Item 6.**Development Application: 11-15 Ralph Street, Alexandria**

File No.: D/2017/839

Proposal Summary: Integrated development application for the demolition of existing buildings, site remediation, excavation and construction of a six storey residential apartment building with one basement level. The proposal comprises 61 dwellings and basement parking for 61 vehicles accessed via Beaconsfield Lane.

Figure 20: Ground floor plan extract, with interface between Apartment 115 and the ground floor common open space area circled in red.

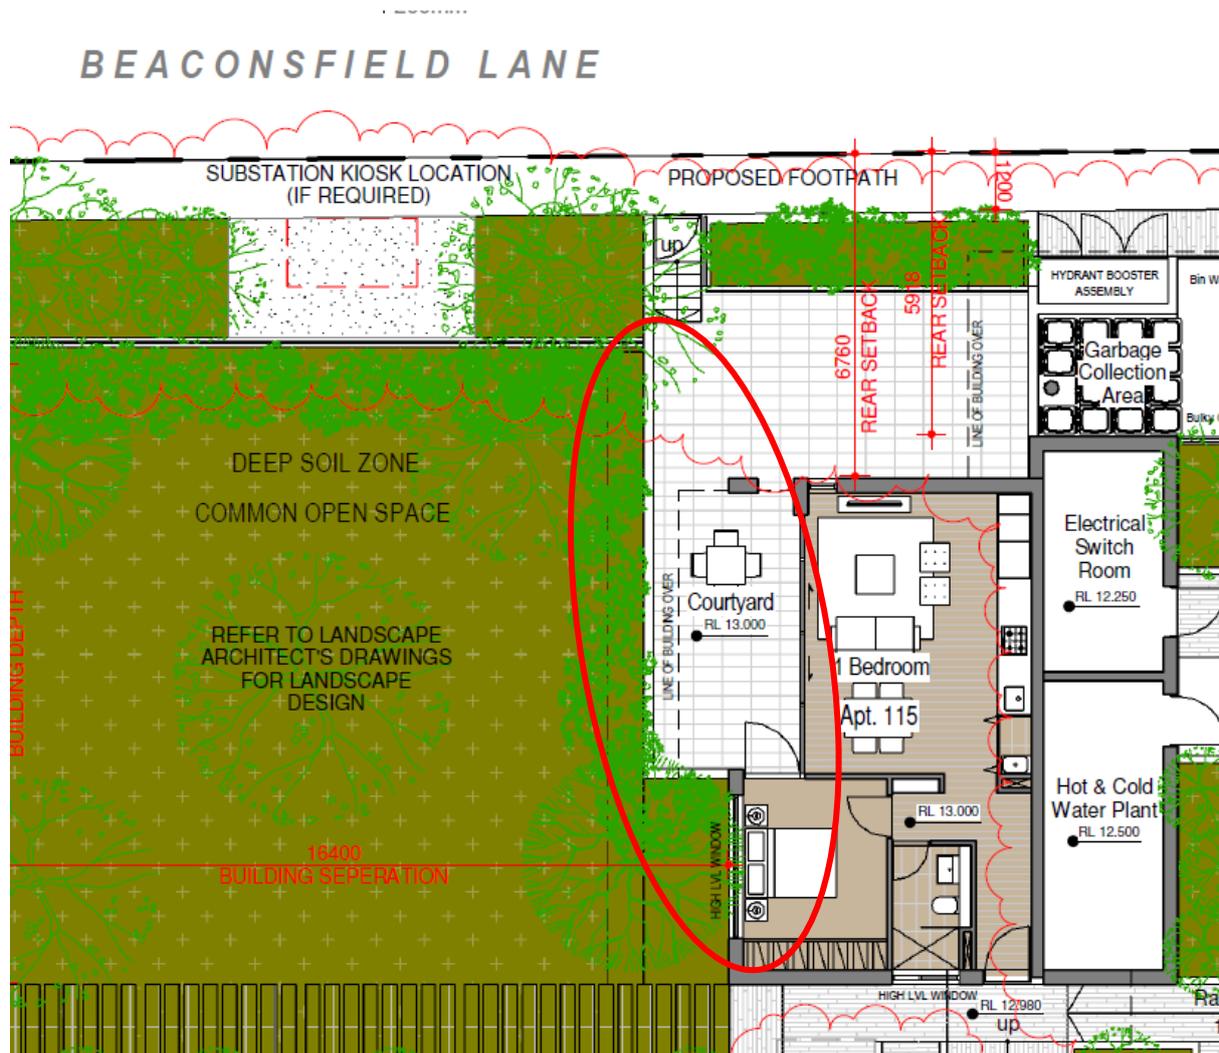
63. The orientation, configuration and design of this ground floor apartment has a poor interface with the adjacent communal open space area, will result in inferior privacy outcomes and result in conflict between the use of the communal open space and the residential amenity of the apartment, as indicated in Figure 20 below.

64. It is also considered that the proposal has not provided sufficient internal communal spaces to satisfy design quality principle 8 in SEPP 65, which requires the provision of different types of communal spaces for a broad range of people, in order to provide opportunities for social interaction among residents. These include common facilities such as a communal room, music practice room and storage for the common open space area.

65. In order to satisfactorily resolve these matters, a design modification condition is recommended requiring the deletion of Apartment 115 and its replacement with communal rooms and a connection to the central communal open space at the ground floor level.

Figure 21: Section drawing extract of proposed plenum arrangement.

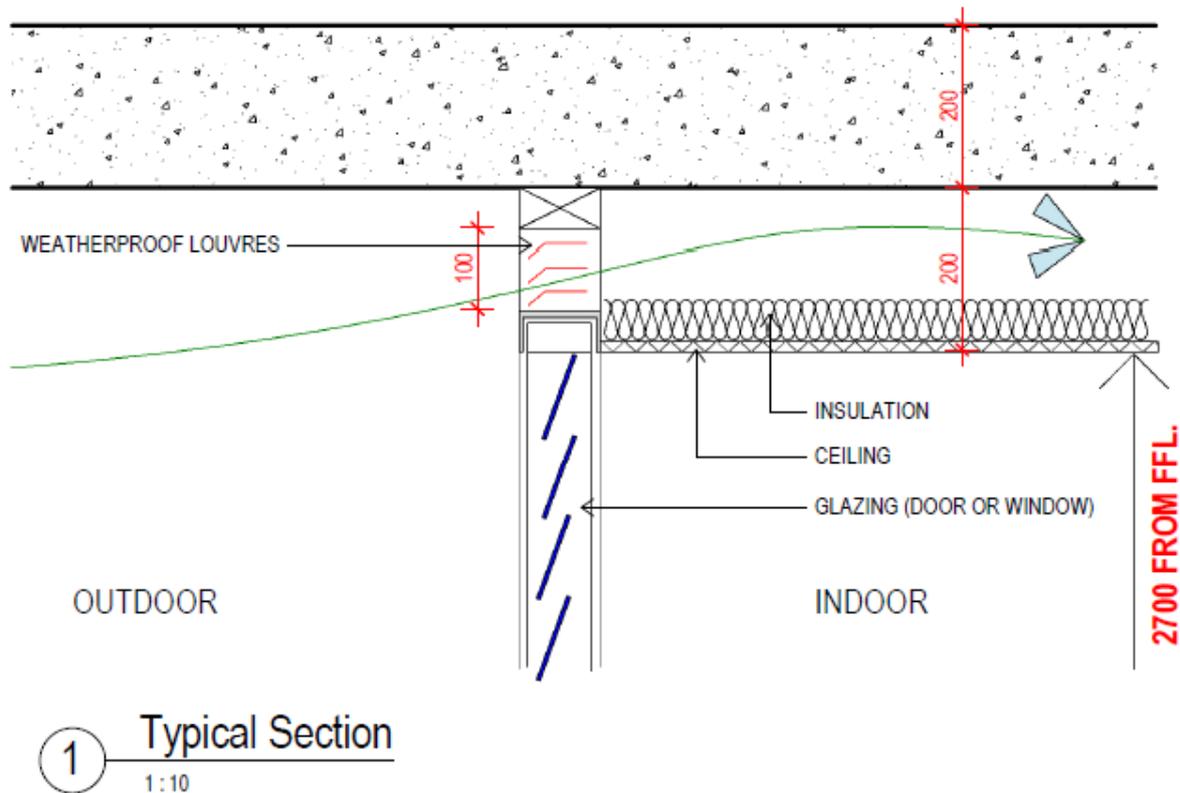
70. The amended application was accompanied by detail drawings proposing an acoustically treated plenum arrangement. This relies on mechanical fans to draw fresh air into the apartment bedrooms, as indicated in Figure 21 below, which does not satisfy Objective 4B-1 of the ADG.

71. The City has had the detail plans and the accompanying information peer reviewed by a sustainable building consultant.
72. The peer review has identified that while the design has the capacity to accommodate a plenum arrangement that does not rely on mechanical ventilation, further work is required so that all apartment bedrooms are provided with natural ventilation and can achieve the natural ventilation requirements of the ADG and the DCP acoustic privacy criterion.

73. Appropriate conditions requiring design modifications and details have been recommended to be imposed.

Figure 22: Plan drawing extract of typical setback bedroom arrangement.

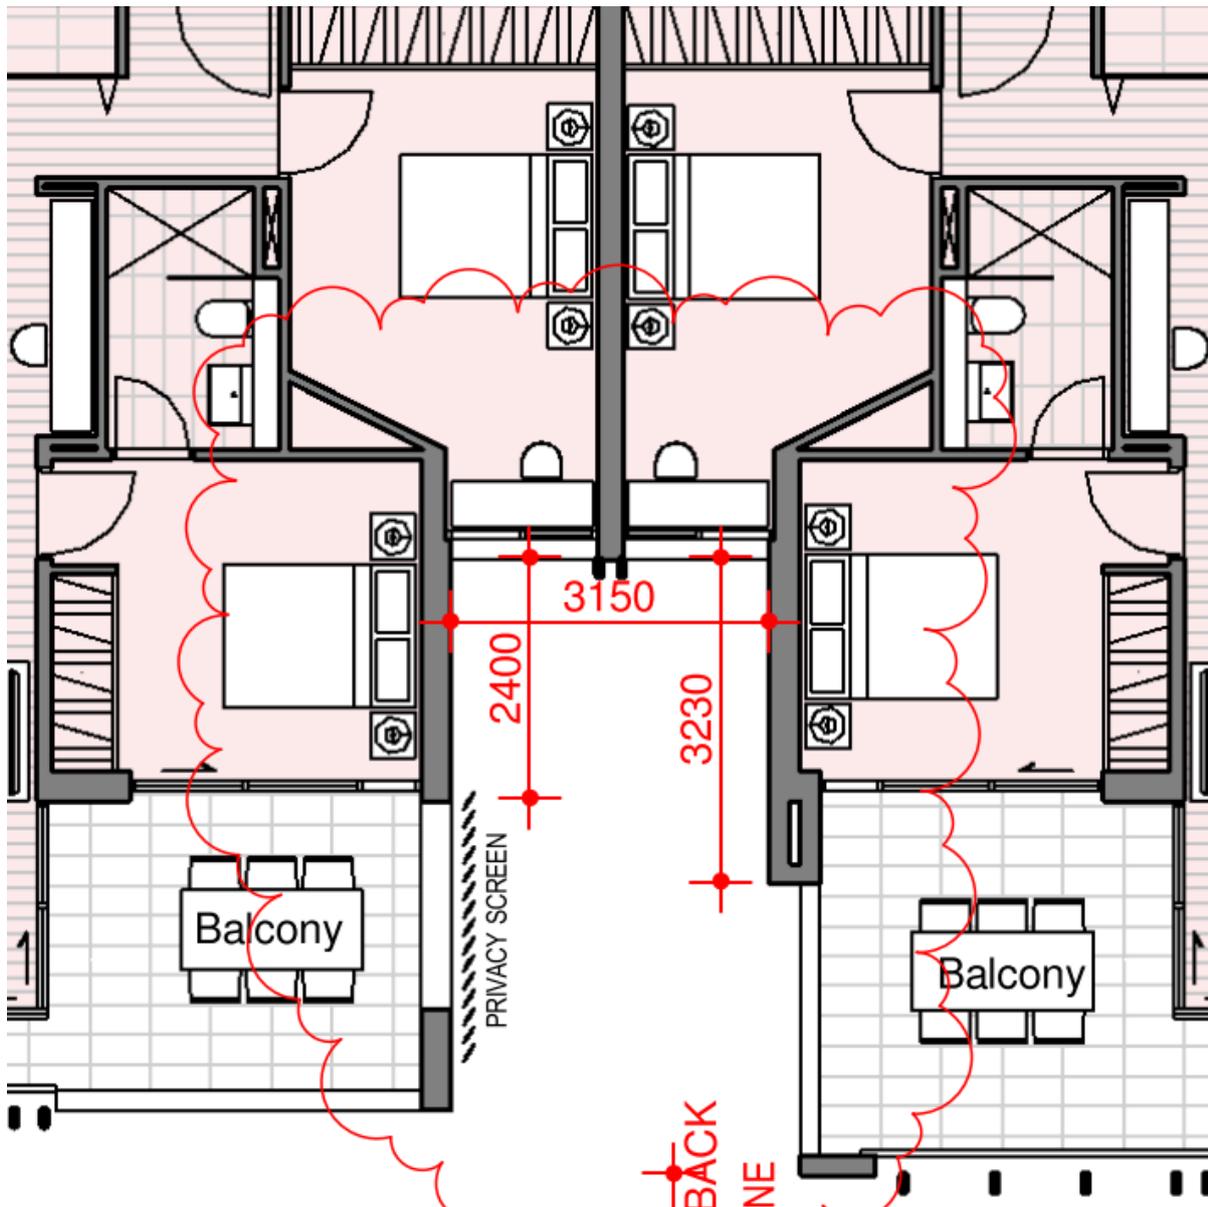
75. The proposal includes 16 apartments with setback bedrooms, which comprises 26% of the total number of dwellings in the development. Figure 22 below, illustrates an example of the setback bedroom typology on the Ralph Street frontage.

- (c) Appropriate design modification conditions are recommended to ensure that the bedrooms are provided with adequate ventilation amenity, including:

- (iii) The window desks to bedrooms with windows to the two building indentations fronting Ralph Street to be deleted; and

- (iv) The windows to the building indentations to be full height from spandrel to ceiling, with upper and lower panes fully operable.
